Summary of Progress on Mixing Segment Specifications in 802.3da

G. ZIMMERMAN, CME CONSULTING

3/9/2023 – UPDATED 3/14/2023

IEEE P802.3DA SPMD TASK FORCE - MARCH 2023 PLENARY

Figure 168–17—Mixing segment and reference points

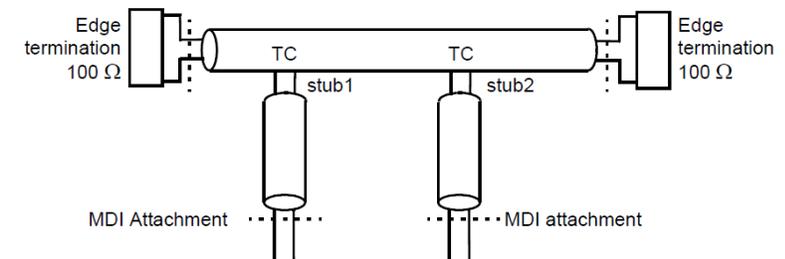
IL of trunk specified between edge terminations without MDIs or loads attached

- Are unterminated stubs attached?, If there is compensation at the TC, is that attached?

IL and delay of (separated) stub from TC to MDI attachment point specified

RL at MDI attachment point without MDI or other loads attached is specified

- If compensation is used, is that attached?

RL at Edge terminations is specified without any MDIs or loads

- Are unterminated stubs attached?, If there is compensation at the TC, is that

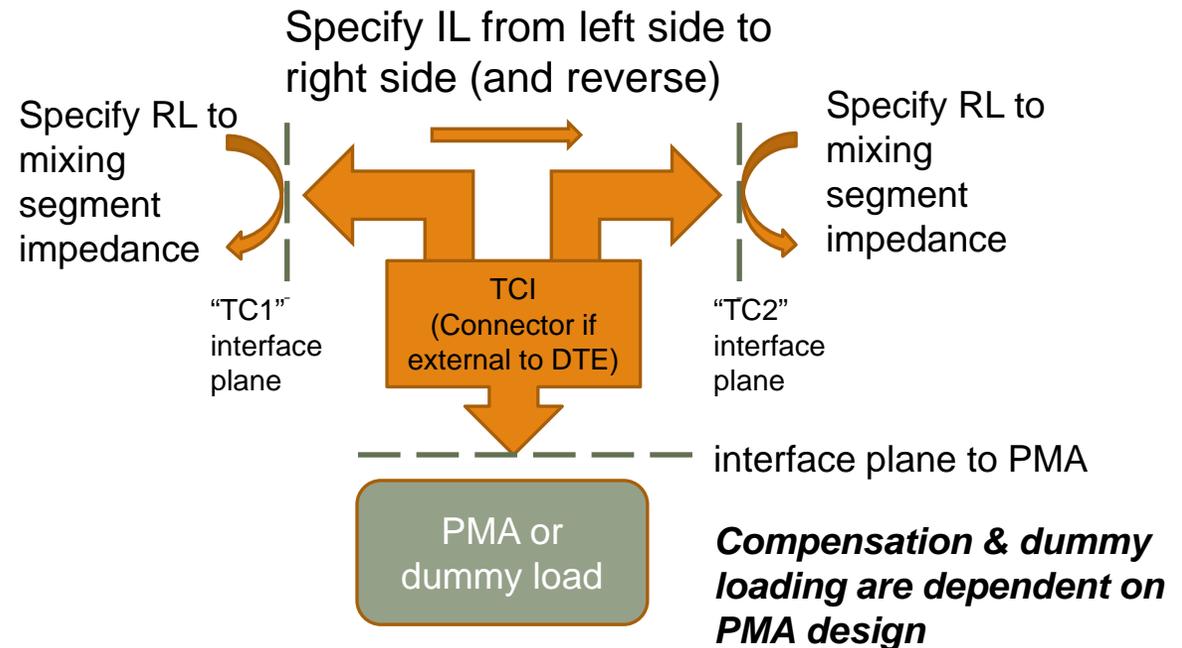
TCI connects to left and right trunk pairs and presents both sides as a 4 pin interface to the PMA (MDI plane)

The TCI meets different RL & IL specs depending on whether PMA/loading is or is not attached

When no PMA attached, the TCI maintains continuity between the left and right sides of the mixing segment as part of mixing segment (like an inliner)

When a PMA is attached, the TCI routes continuity of through 4 signal interface (p_{left}, n_{left}, p_{right}, r_{right}) to the PMA, PMA completes the path from left to right

Normal RL specs associated with the MDI are met at both the left and right side of the TCI – not at a single MDI interface plane

TCI specification contains the left to right side insertion loss when the PMA is attached

168.7.2a Trunk Connection Interface

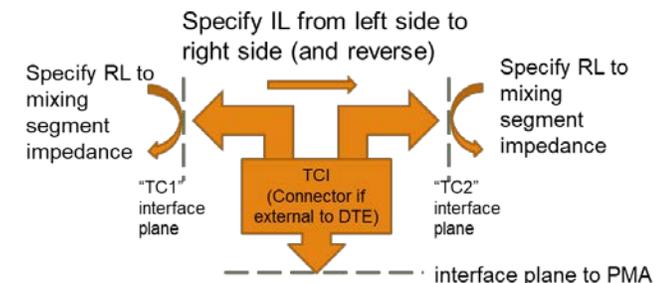
The TC adaptor and the PMA attachment may be located within a single assembly, presenting negligible stub length when the PMA attachment is open circuit, and may include compensation engaged when a PMA or PMA load is attached. **(NOTE – should we specify the length of a stub, and if so, how – in cm? In ns delay? – alternatively, as TBD shunt capacitance based on the various studies?)**

The Trunk Connection Interface (TCI) connects the left and right sides of the mixing segment together (trunk port CP1 and trunk port CP2) and has a third port to attach the PMA at the MDI attachment point (see 168.7). The TCI is part of the mixing segment, and the requirements of 169.7 are met with TCIs in place with or without attached MDIs as specified for the particular specification.

A TCI may be a “T” type connector to provide a mean of connecting the segments of balanced conductors and attaching a PMA to the trunk. The connection is specified so as not to disturb the transmission line characteristics of the trunk conductor significantly, except for the increased insertion loss when loaded with a PMA. TCI’s with compensation are expected to be matched to a particular PMA.

Without a PMA or PMA loading present, the differential insertion loss of the TCI between the trunk ports shall be less than **TBD dB (small number)** from 0.3 to 40 MHz, in each direction, measured into 100 ohms.

With the specified PMA or PMA present, the differential insertion loss of the TCI between the trunk ports shall be less than **TBD dB (allows for compensation and phy loading – may be an equation)** from 0.3 to 40 MHz, in each direction, measured into 100 ohms.

Without a PMA or PMA load present at the TCI attachment, the return loss of the TCI at port CP1 and CP2 shall be greater than Equation 169-X with the other trunk port terminated in 100 ohms. **(NOTE – this is to allow meeting the unloaded trunk RL spec)**

With a PMA or PMA load present at the TCI attachment, the return loss of the TCI at port CP1 and CP2 shall be greater than Equation 169-Y with the other trunk port terminated in 100 ohms. **NOTE - this specification replaces the MDI return loss and is measured at the TCI.**
